# EMU Master Plan Change 2014

## Rezoning – R-3/I-1 Master Plan Amendment

## Master Plan Narrative

August 2014

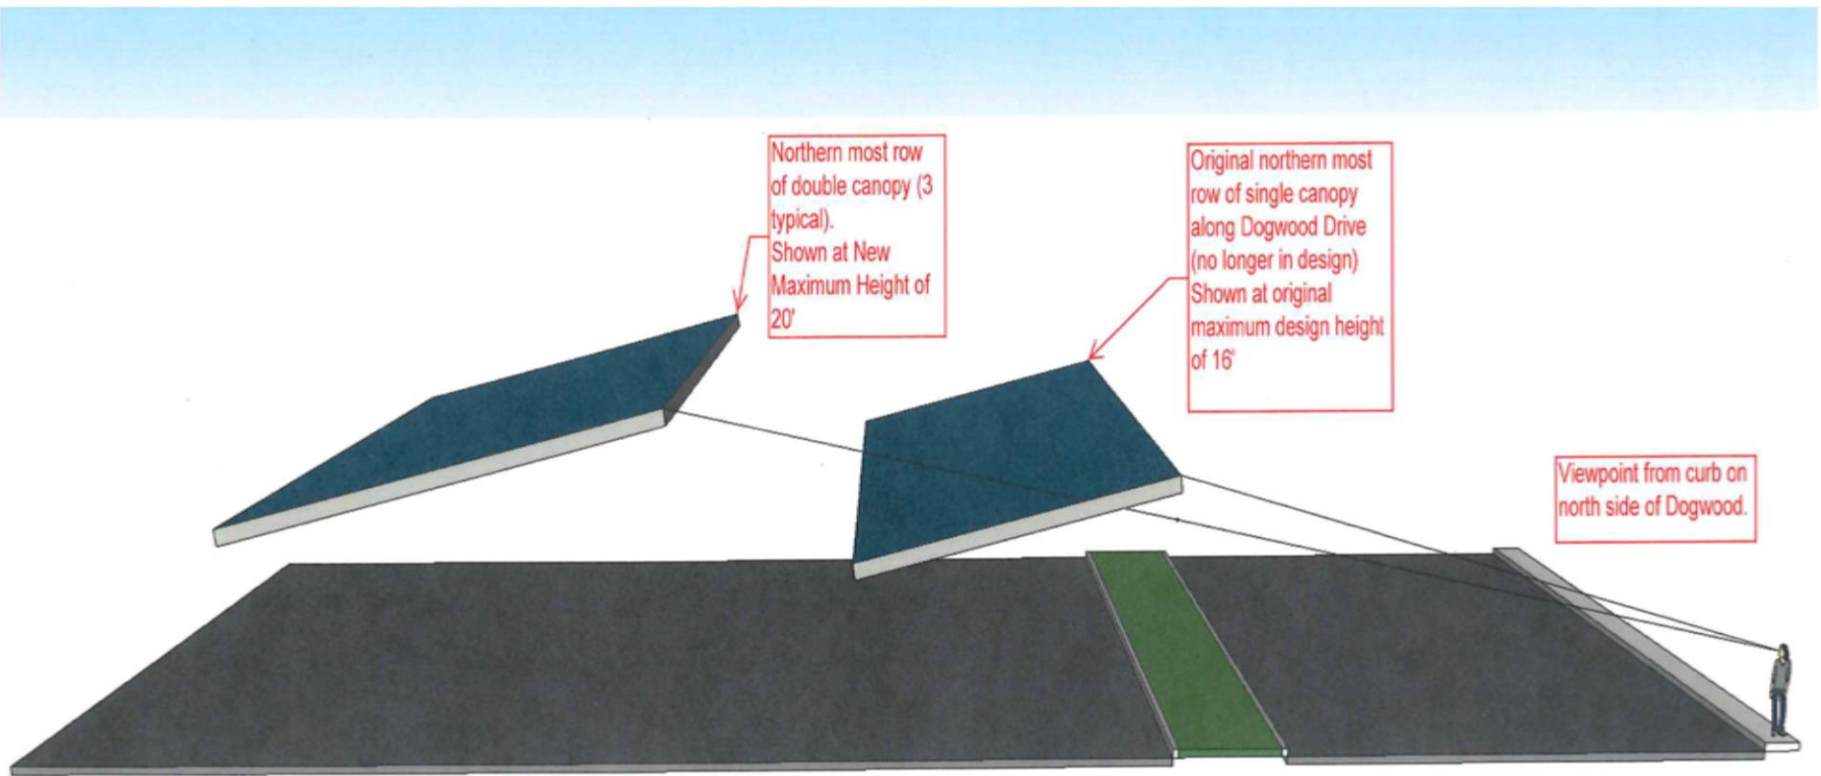
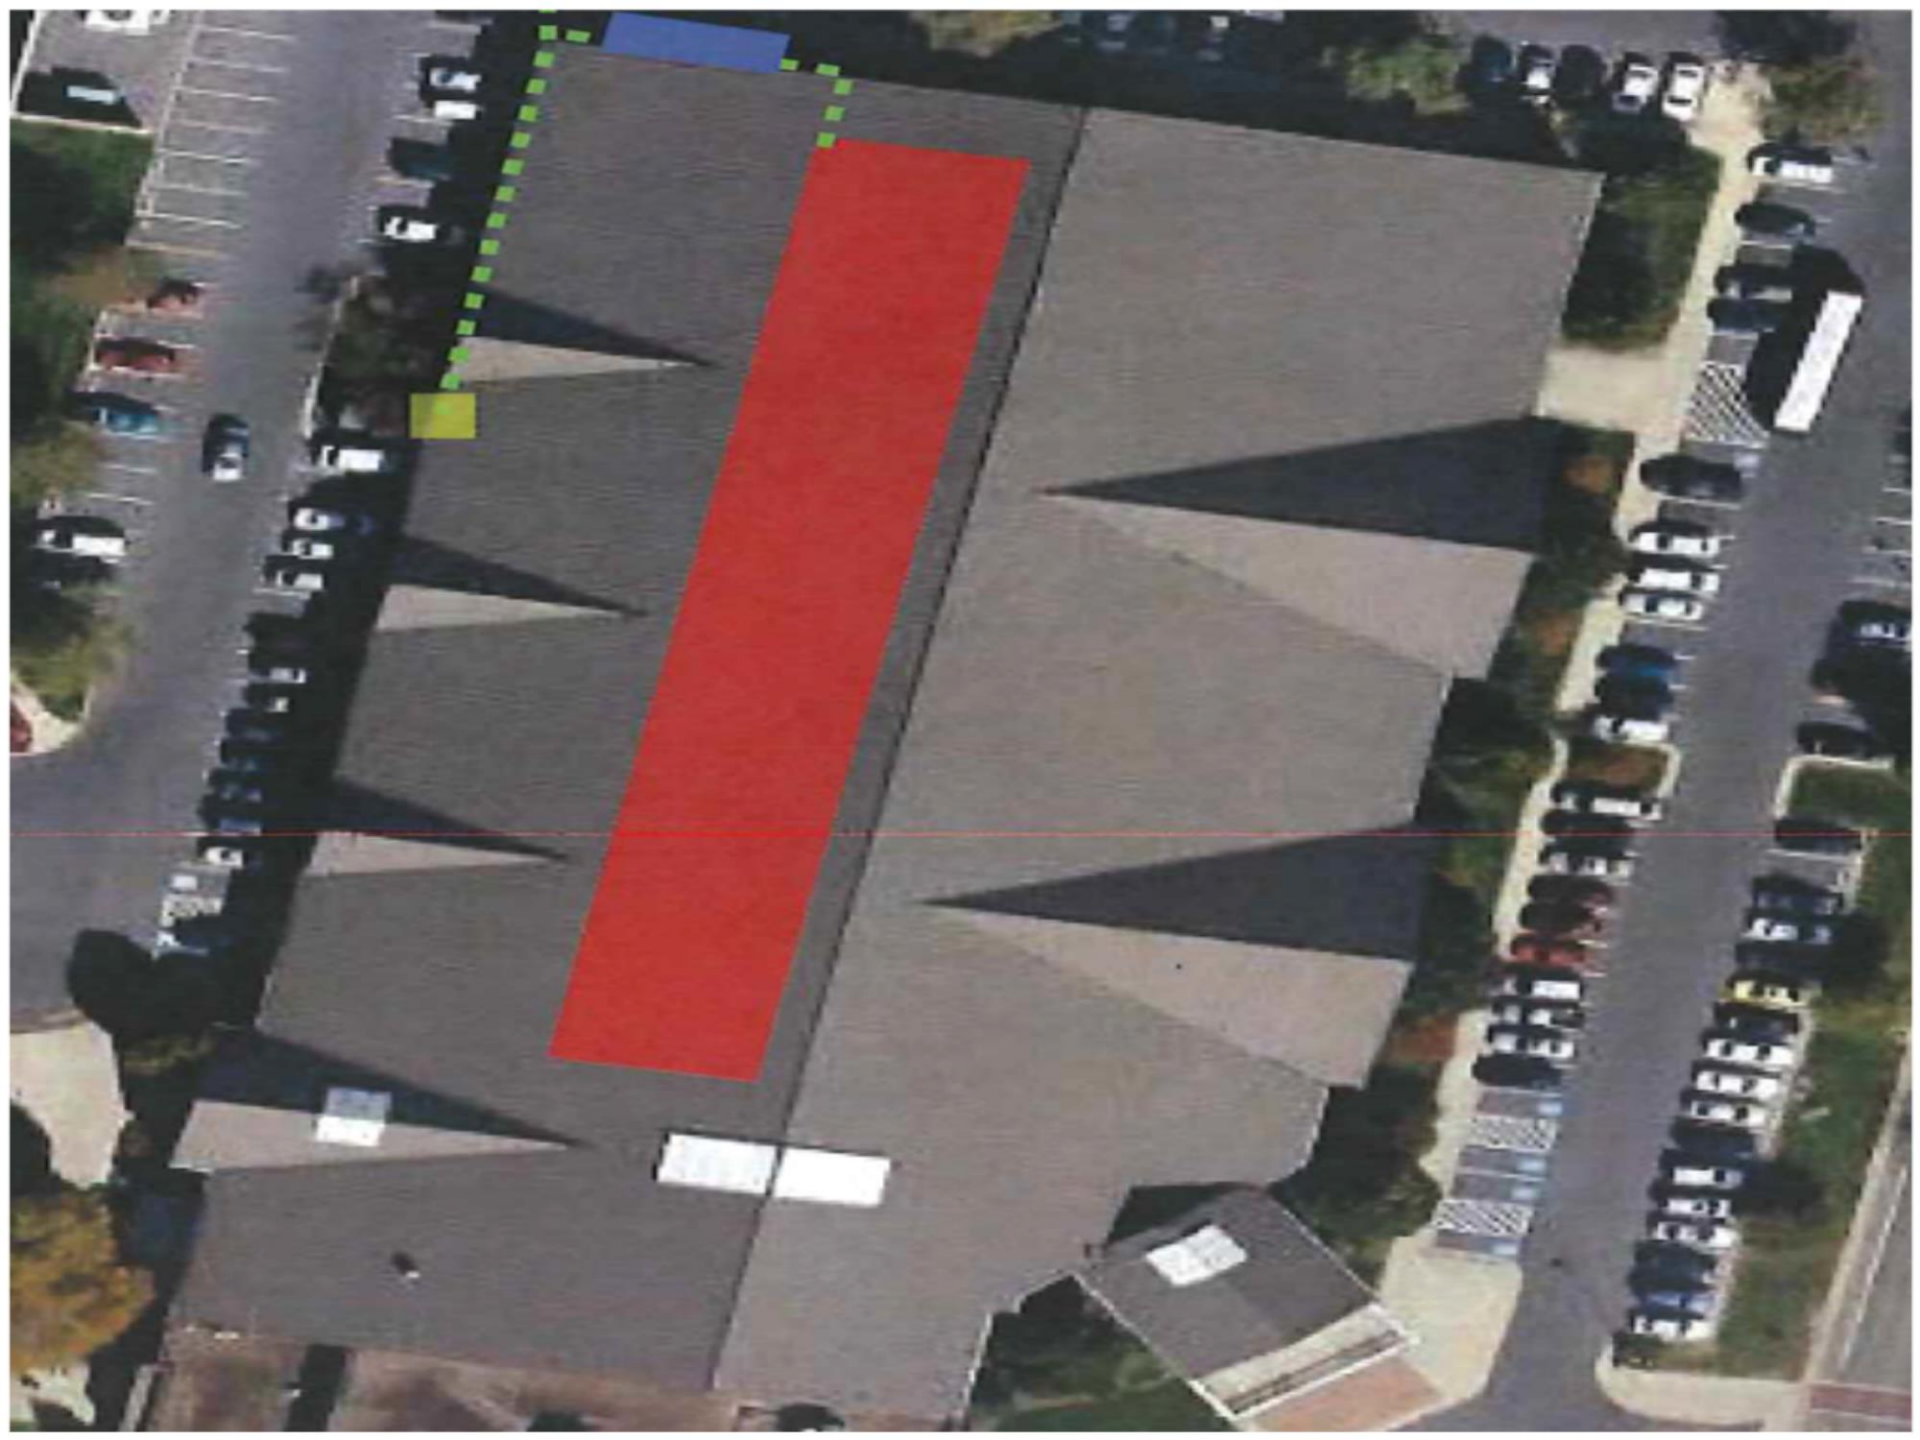
By eliminating the northern most single row, the visual impact to residences along Dogwood Drive is reduced by 2'-8", despite an increase in maximum design height to 20'. The minimum design height remains at 8'-6" for clearance and safety.

Note: The proposed single width canopy structure adjacent to Dogwood Drive has been removed from consideration. The array will consist of three identical double width canopy structures. Removing the canopy adjacent to Dogwood from the plan, will allow the visual impact on Dogwood Drive property owners to be reduced by 2' 8" despite the increased height. See attached schematic.

- b. University Commons parking lot: The parking lot north of the University Commons will serve as a second location for a multi-panel array of solar cells. These panels will rest on a carport style support structure, allowing the current parking lot to remain in use. The cars park underneath the panels, enabling no loss in the number of parking spaces. These panels (or tiles) vary in height from 8.5 to 10 feet in the front to ~~14 to 16~~ *16 to 20* feet at the rear of the panel. The support columns are spaced 18 *to 27* feet on center. These solar arrays will run parallel with and above the current parking stalls, leaving a 20 foot minimum drive aisle open for vehicular access. ~~The solar panels arrayed adjacent to Dogwood Drive will maintain a 5-foot minimum setback with the property line.~~ Since the solar panels are elevated, the 10 foot landscape buffer shall still be maintained.
